CITY OF SAN ANTONIO

Re: Kallison Ranch Subdivision MDP # 838

The City Staff Development Review Committee has reviewed Kallison Ranch Subdivision Master Development Plan M.D.P. # 838. Please find enclosed a signed copy for your files. Your plan was accepted, however please note the following:

KALLISON RANCH
MASTER DEVELOPMENT PLAN

TYPICAL 120' R.O.W. STREET CROSS SECTION
NOT TO SCALE

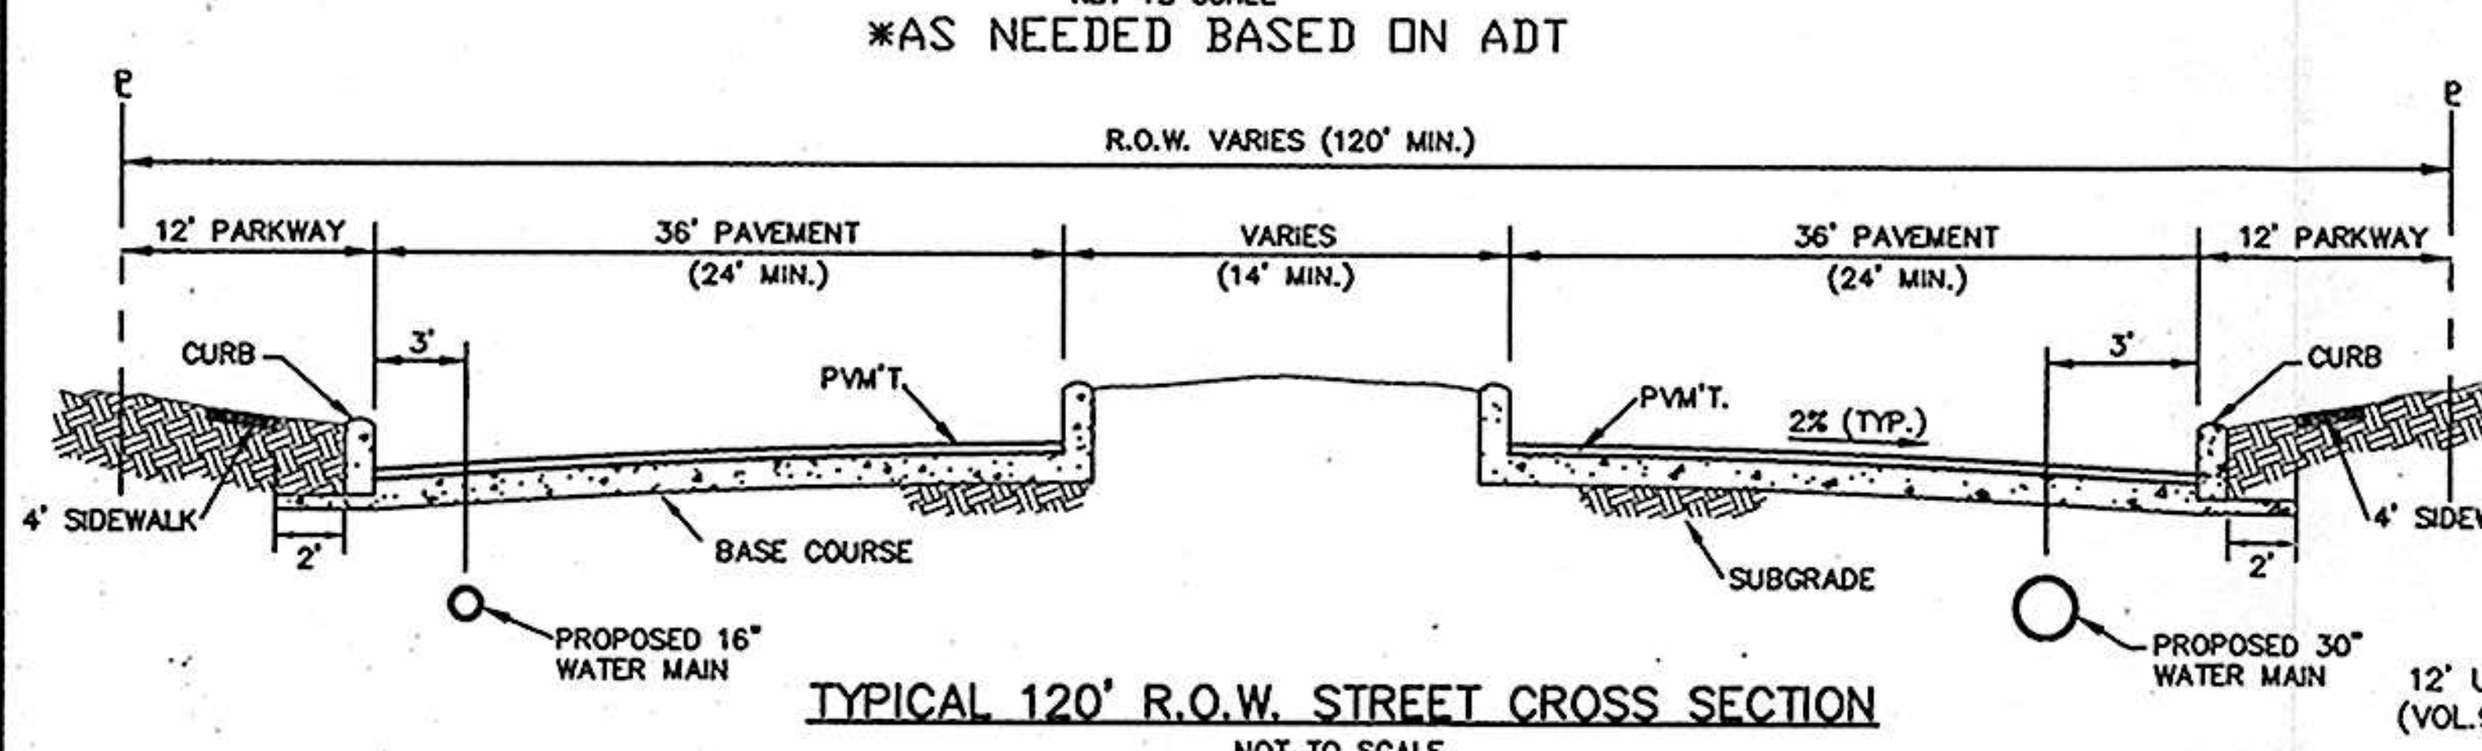
5. ***Existing Talley Road and Talley Road extension (Street 2)*** –Based on the TIA analysis, a minimum of 120-feet of ROW shall be provided at the intersection (existing Talley Road and FM 471), with 70-feet of ROW at the mid block north of Street 1. On street 2 (Talley road extension) 120 feet ROW with separate dual left turn lanes with required storage and bay taper as it relates to the submitted TIA traffic counts and separate right turn lane. On Talley Road, 120 feet ROW with separate dual left turn bays with required storage and bay taper as it relates to the submitted TIA traffic counts and separated right turn lane. On westbound FM 471, construct a deceleration lane with right turn bay and construct dual-left turn lanes with required storage and bay taper as it relates to the submitted TIA traffic counts. On eastbound FM 471 at Talley Road construct deceleration lane and dual left turn lanes with required storage and bay taper as it relates to the submitted TIA traffic counts.

6. ***Street 1/Talley Road (Major Thoroughfare Plan extension)*** – On Street 1, based on the TIA analysis, a minimum of 120-feet of ROW shall be provided at the intersection of Culebra Road to accommodate dual left turn lanes with required storage and bay taper as it relates to the submitted TIA traffic counts. On westbound FM 471, construct a deceleration lane and right turn lane and construct left turn lane with required storage and bay taper as it relates to the submitted TIA traffic counts.

3. The extension of Talley Road into the site will be 70 feet right-of-way, with widening at the intersection with FM 471 to 120 feet to accommodate the necessary turn lanes.

TYPICAL 70' R.O.W. STREET CROSS SECTION
NOT TO SCALE

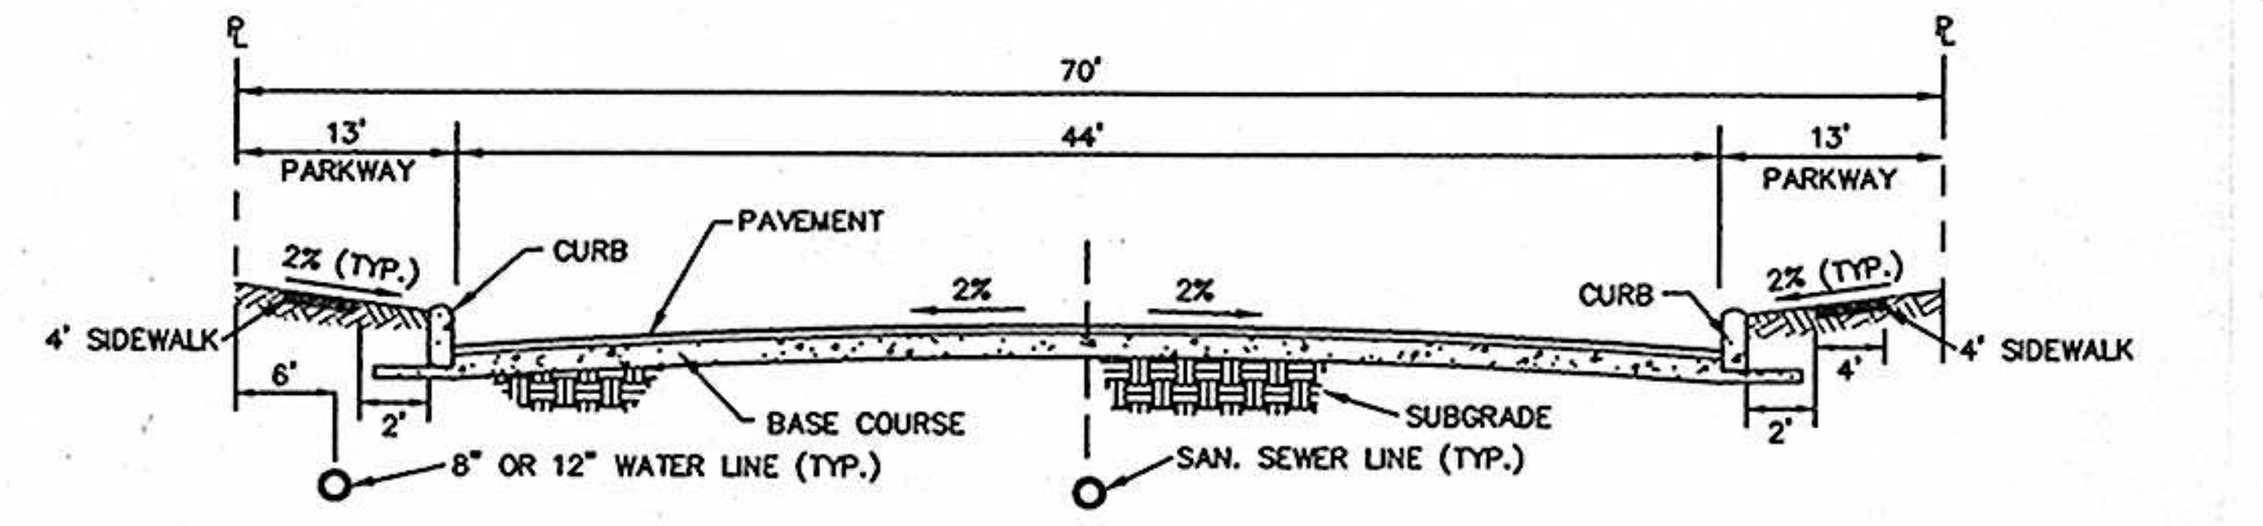
2. ***Street 1 and Street 2 (internal collectors)*** – Construction of an internal collector street system. Collector street design parameters consist of 70-feet of ROW and 44-feet of pavement (Table 506-3). The proposed collector street shall have no houses fronting (UDC 35-515, (c), (4)). The ROW is to be widened to 86 feet at internal intersections to accommodate separate left-turn bays in accordance with TIA requirements. This widening should occur for 300-feet before and after the driveway or intersection along with appropriate ROW transition. Street 2 - construction of an internal Arterial Street System (86-feet of ROW) from FM 471 (Culebra Road) to Street 1 approximately 2100-feet in length.

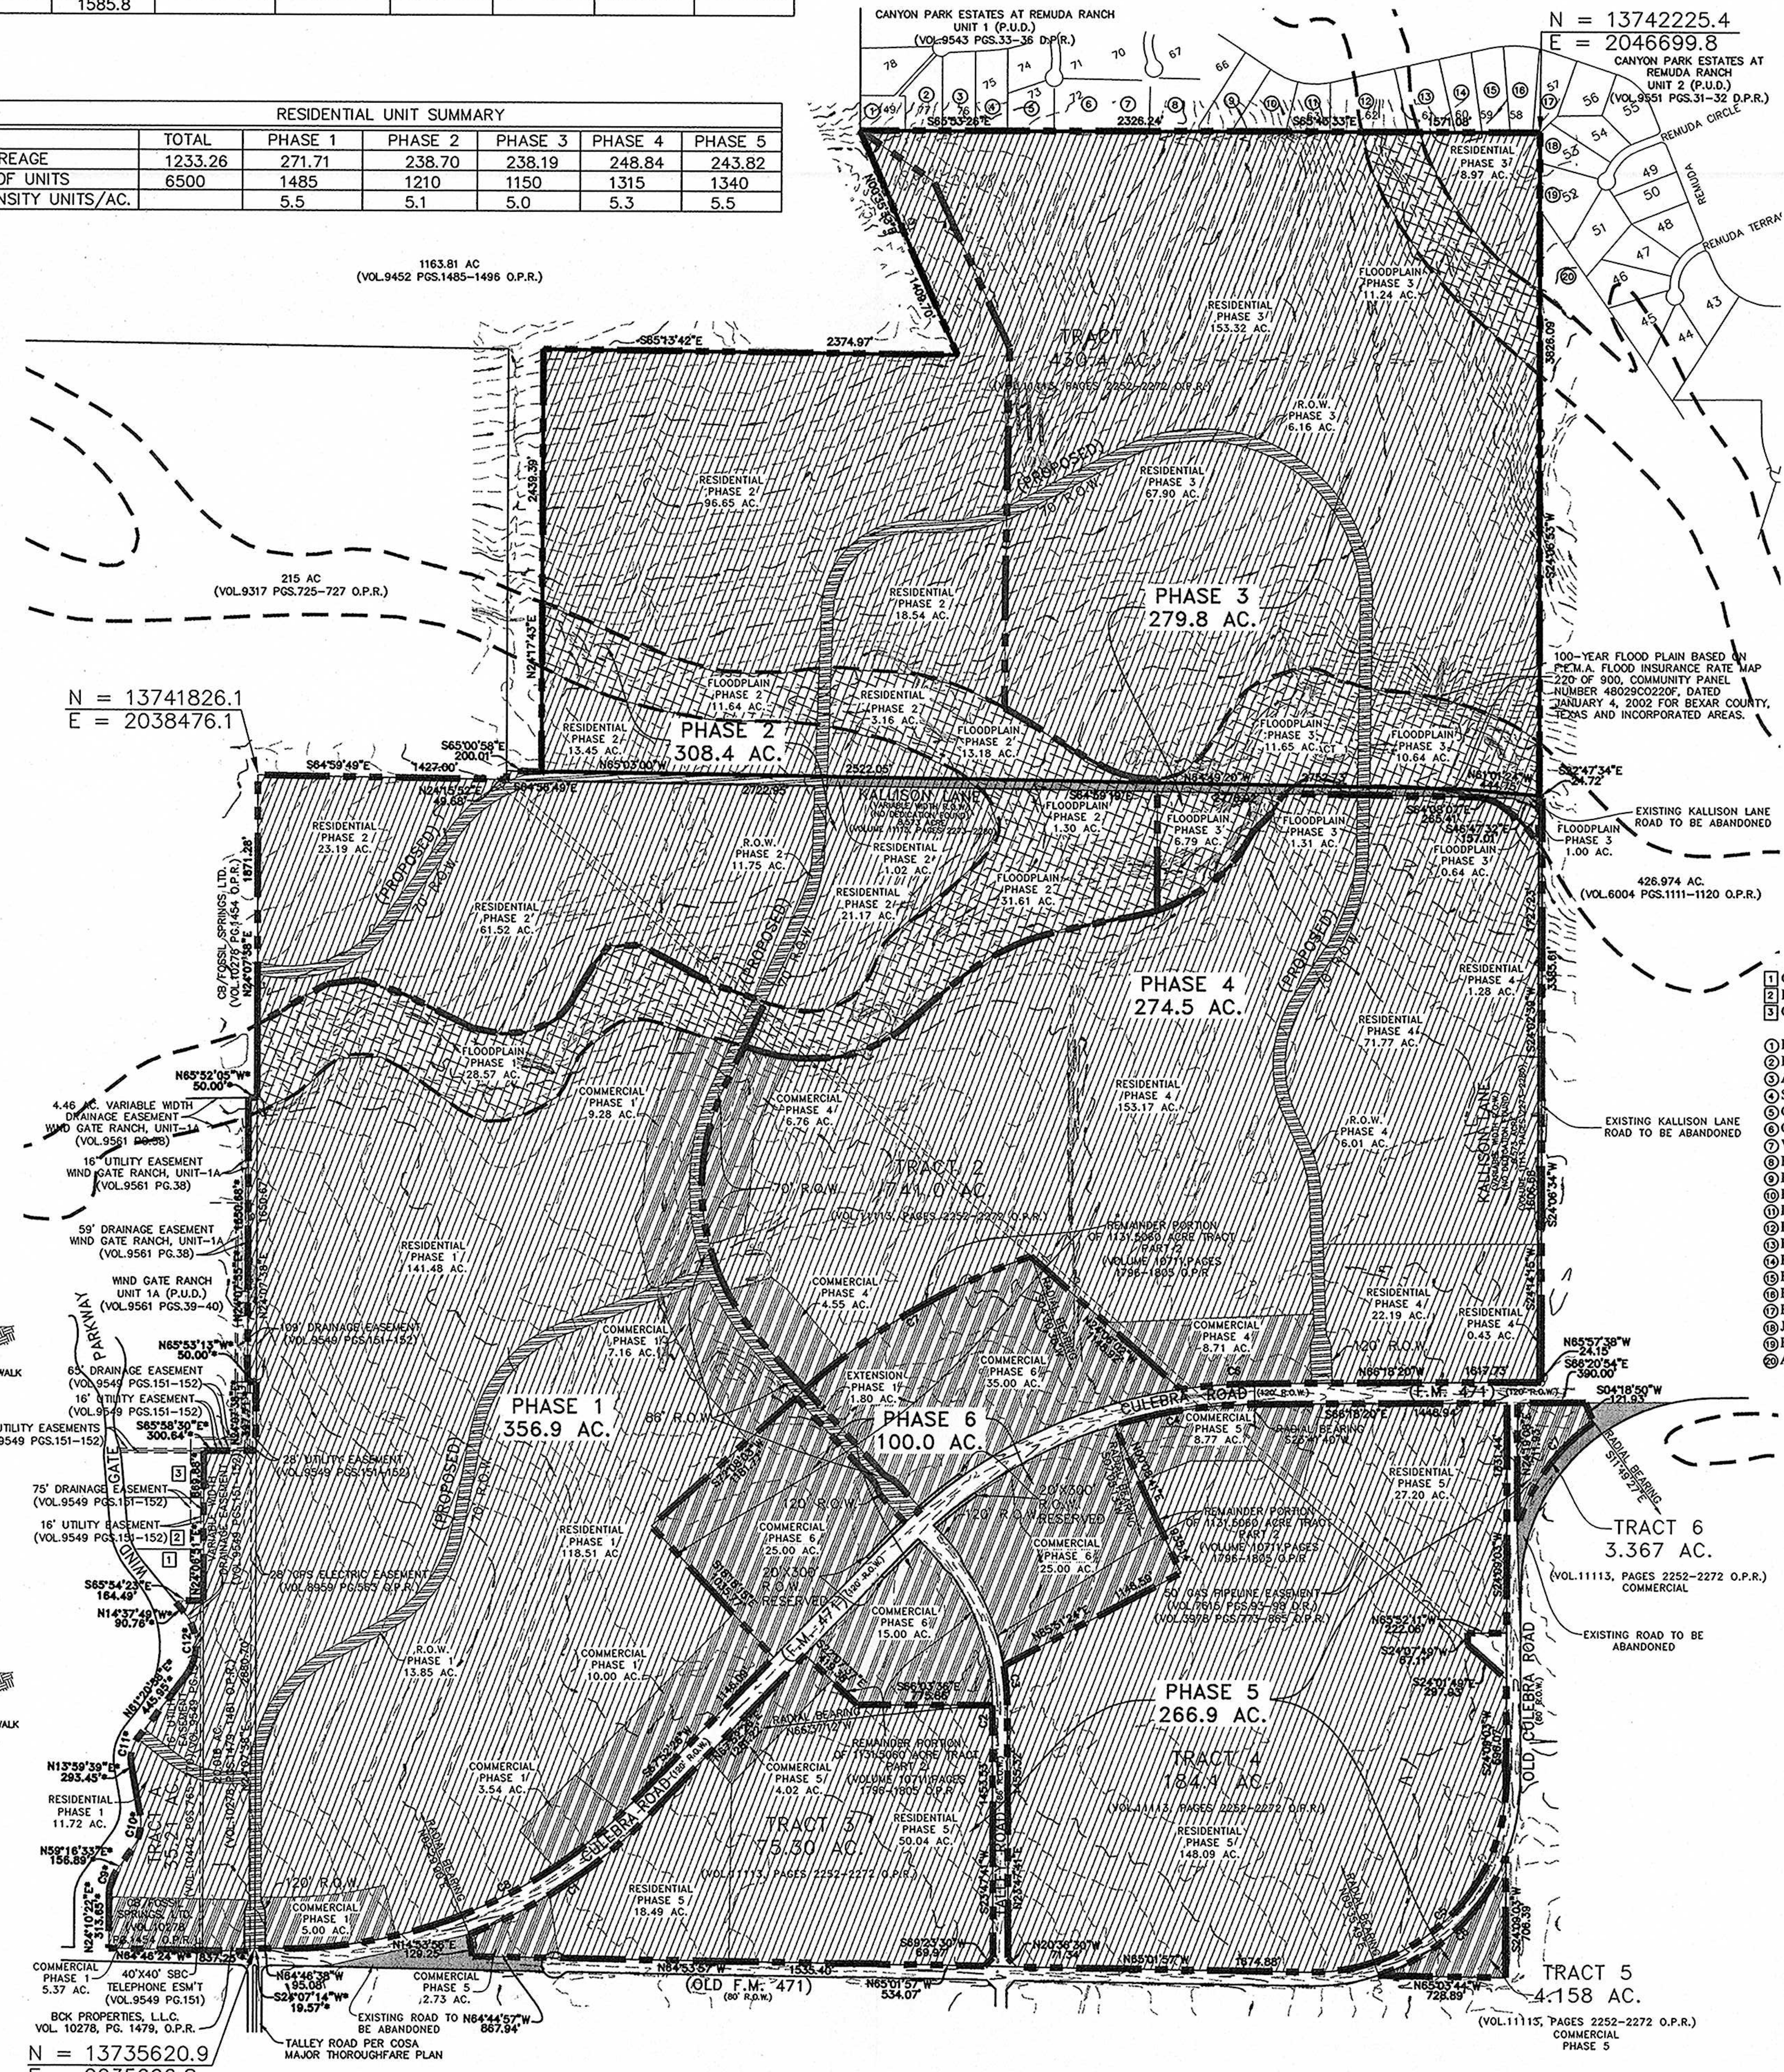
1. **ROW Requirements** – Length of ROW widening for Street 1 and Street 2 at FM 471 (Culebra Road) to comply with left turn bay storage lengths as required by TIA. ROW requirements dictate widened ROW beyond the 200 feet with 100 transition shown on the MDP. Length of ROW widening in accordance with the TIA for Streets 1 and Street 2 at FM 471 to be required at platting.

3. ***FM 471 (Culebra Road)*** – The Developer shall dedicate 60 feet of ROW (Ordinance 98282, October 2, 2003 Major Thoroughfare Plan (MTP)) from the centerline of FM 471 (Culebra Road) (Primary Arterial Type A – Uniform Development Code (UDC) 35-506, (g), (2)) adjacent to this proposed project. Based on the TIA analysis, a minimum of 160-feet of ROW shall be provided at the intersections to accommodate the turn lanes improvements, with 120-feet of ROW at the mid block to accommodate six lanes. The total length of property frontage is approximately 1.6 miles.

12. Revise note 2, "street layouts, phasing, and density are preliminary and change requires resubmittal of the TIA report."

1. FM 471 (Culebra Road) will require 120 ft ROW mid-block and 160 ft ROW at each intersection to accommodate additional necessary turn lanes. As an interim, the following intersections are recommended to be upgrade with exclusive right-turn and left-turn lanes on FM 471 as per TxDOT standards.

2. Old FM 471 will be realigned at FM 471 East, creating a perpendicular intersection. The diagonal intersection of Old 471 and FM 471 West will be eliminated.
